Project:	2114TN
Initial Issue Date:	11/08/2021
Revision Date:	
Page:	1 of 3

DESCRIPTION OF CHANGES

NEW REPAIR SHOP & BLAST/PAINT FACILIT AITX RAILCAR SERVICES, LLC BROOKHAVEN, MISSISSIPPI

Sheet **UG2.0**

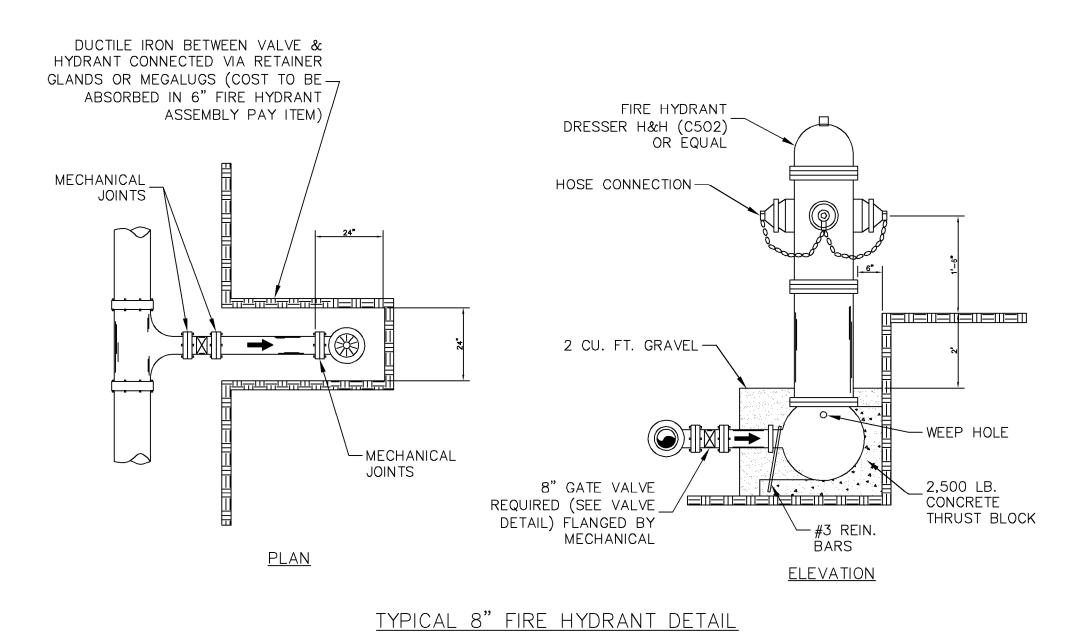
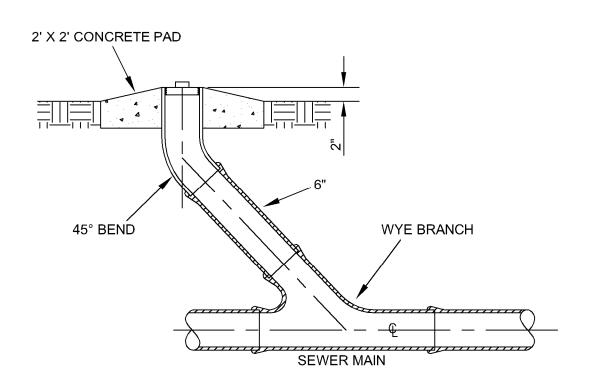
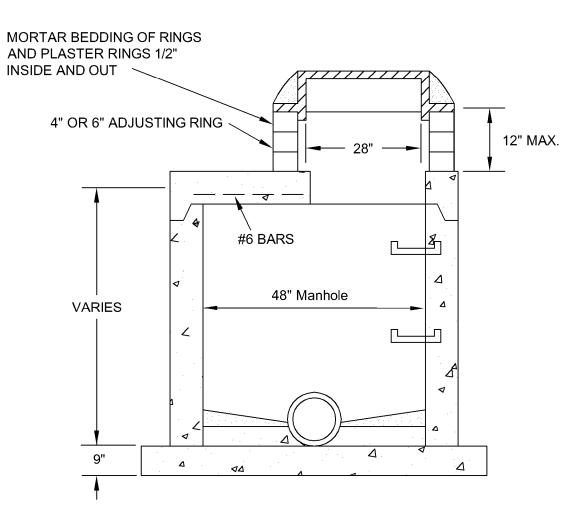
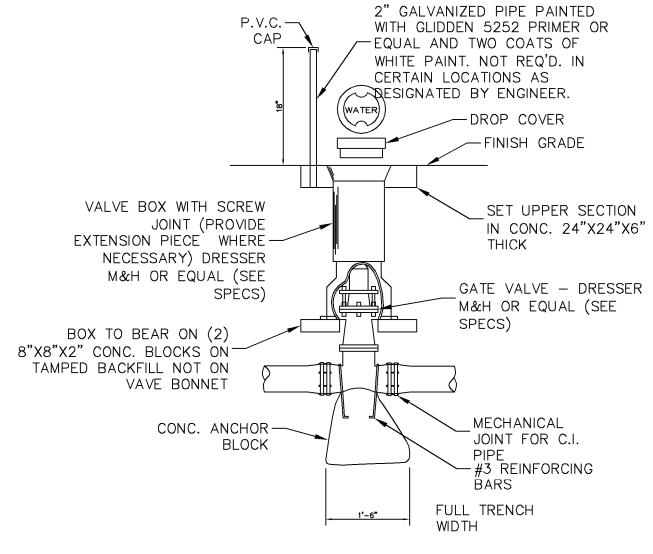
CIVIL	
C1.4	Revised Note - Ex. water line to be abandoned
C2.0	Added scale bar
C2.3	Scale note changed to 1"=60'; Added scale bar
C3.0	Added scale bar
C3.4	Scale note changed to 1"=100'; Added scale bar
C3.5	Changed scale bar to 20 scale
C3.6	Changed scale bar to 20 scale
C3.7	Changed scale bar to 20 scale
C3.8	Changed scale bar to 20 scale
C3.9	Changed scale bar to 20 scale
C3.10	Changed scale bar to 20 scale
C3.11	Changed scale bar to 20 scale
C5.0	Added scale bar
C5.1	Added scale bar
C5.2	Added scale bar
C5.3	Added scale bar
C5.4	Added scale bar
UG1.0	Added hydrant flow test information; Re-configure domestic and fire water piping.
UG2.0	Water meter vault removed in its entirety
STRUCTURAL	
S0.1B	Revised note 3100.02 to include 3,000 PSI mix.
S0.1R	Revised note 3100.02 to include 3,000 PSI mix; Added section 12
	Added section 12/S0.1R to interior rail foundation; Added section 9/S0.1R to exterior rail

S1.1R

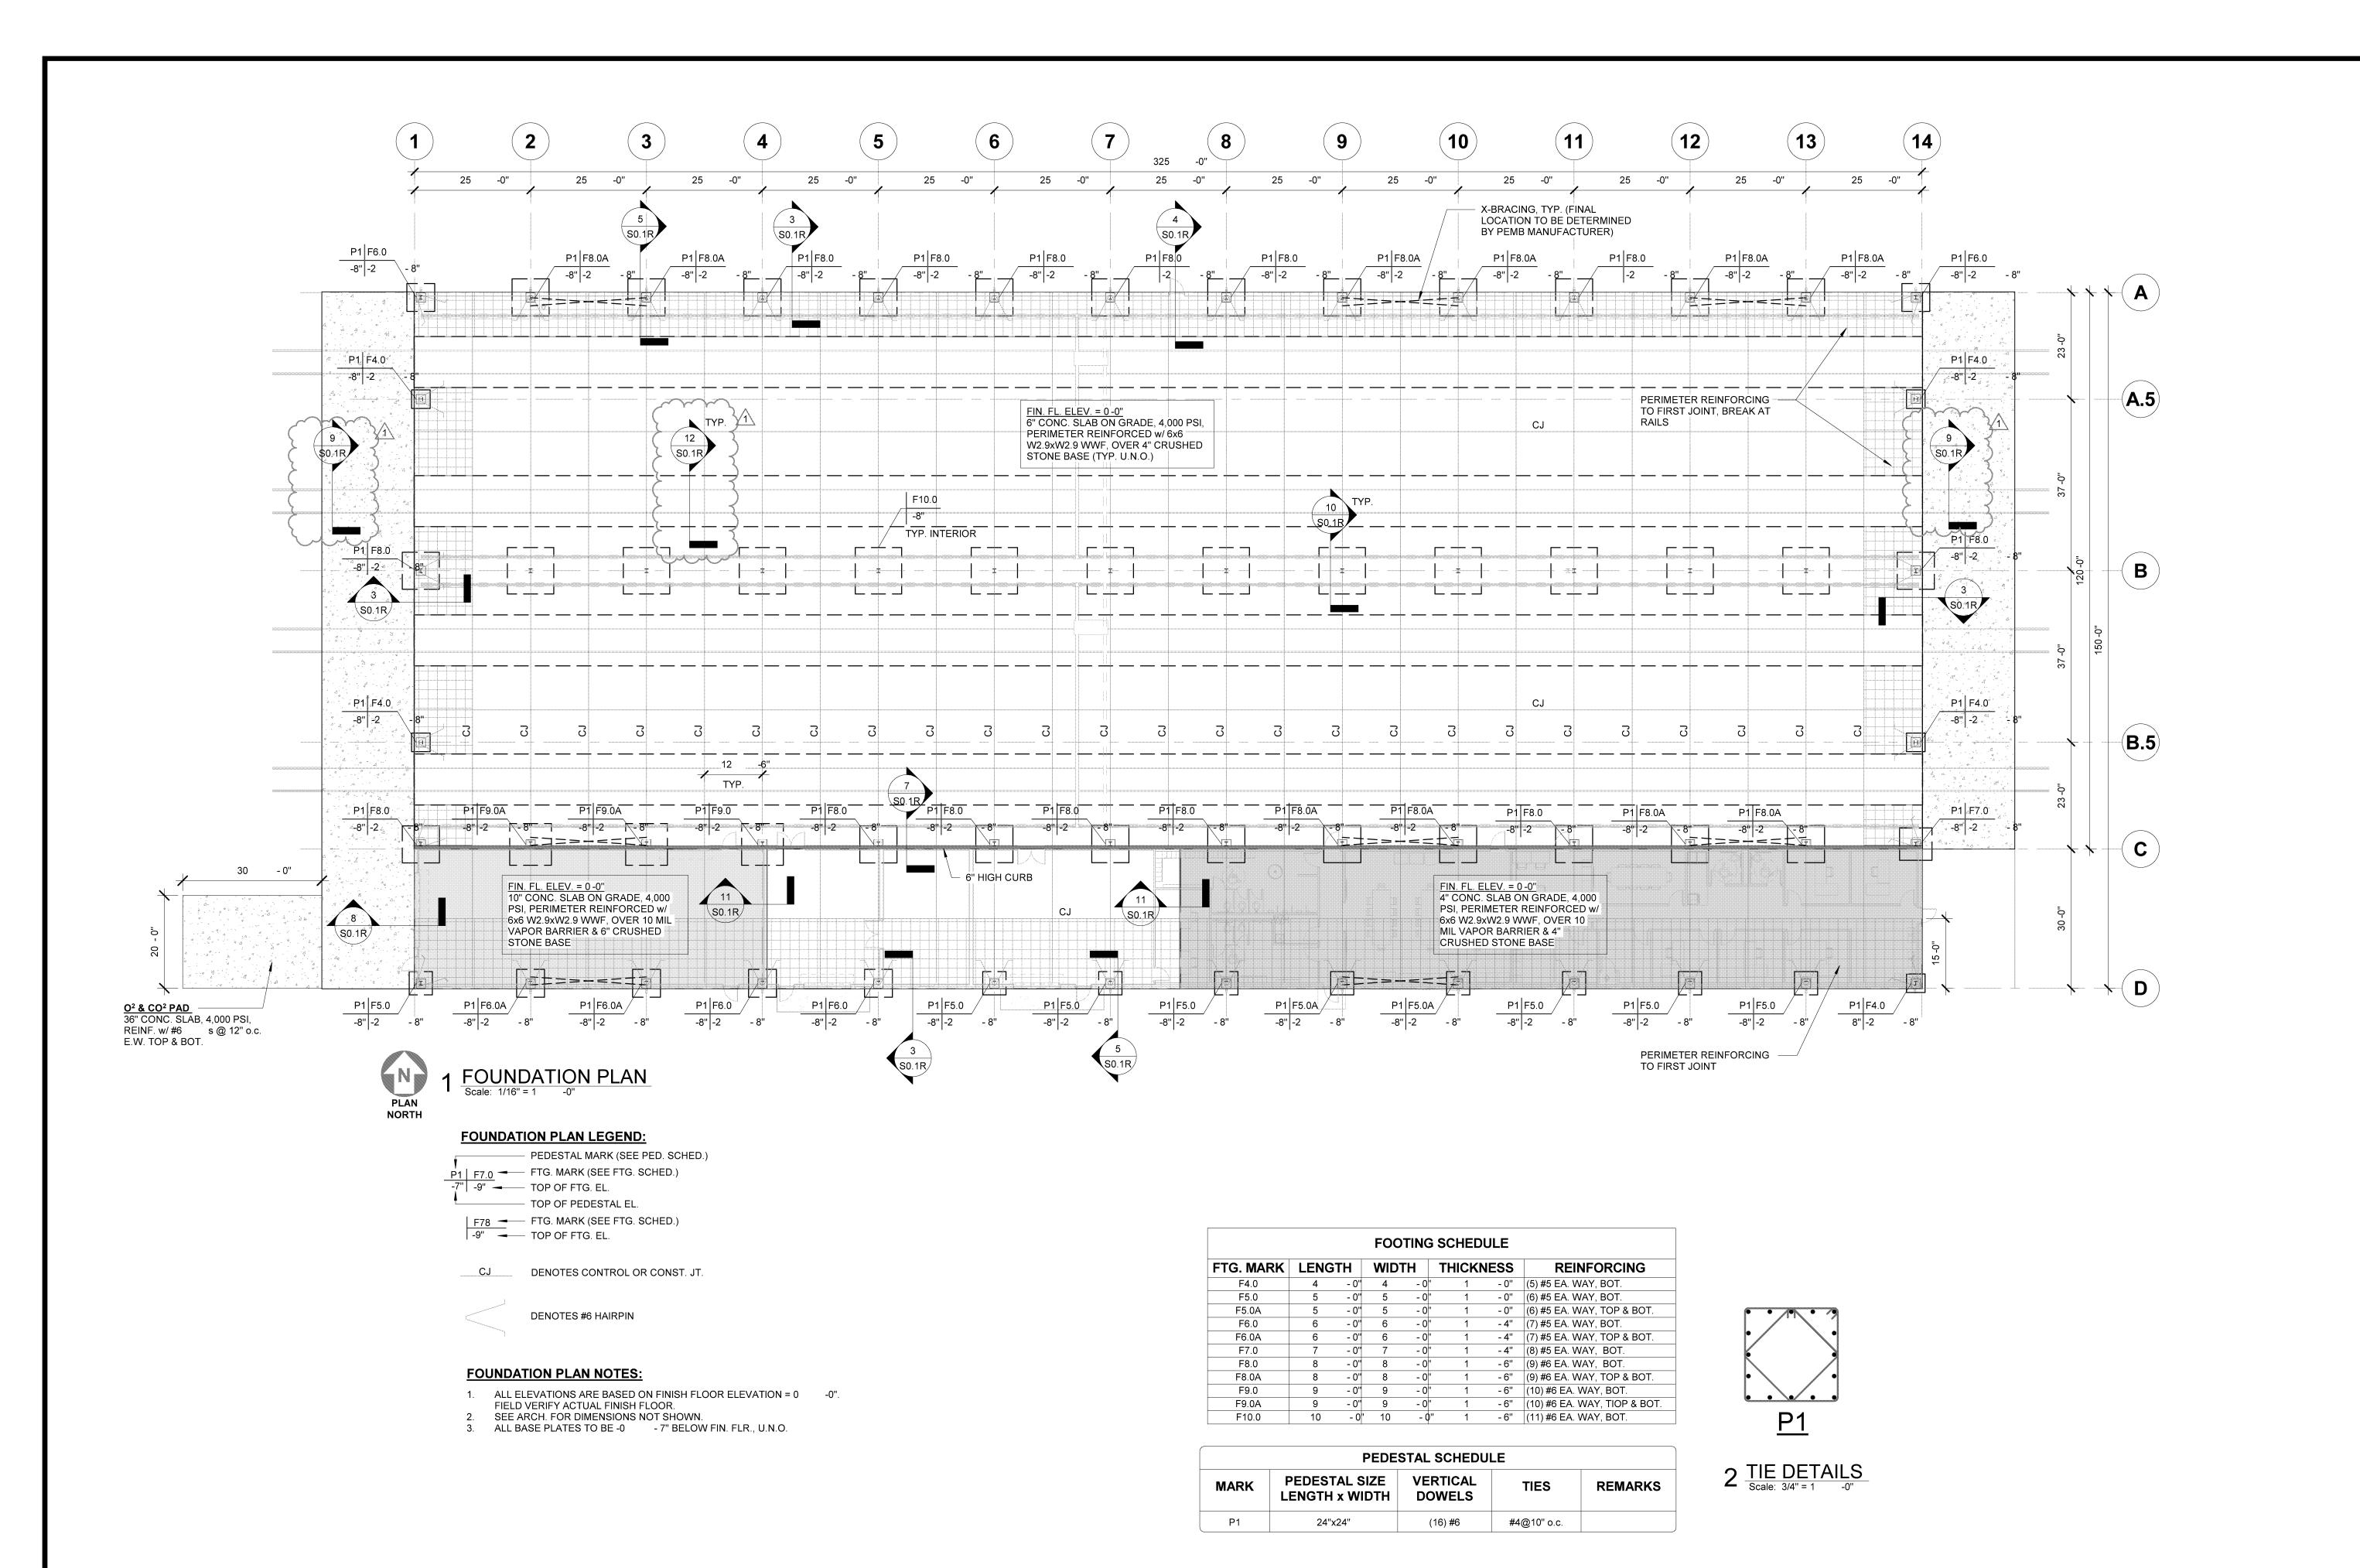
S1.1R
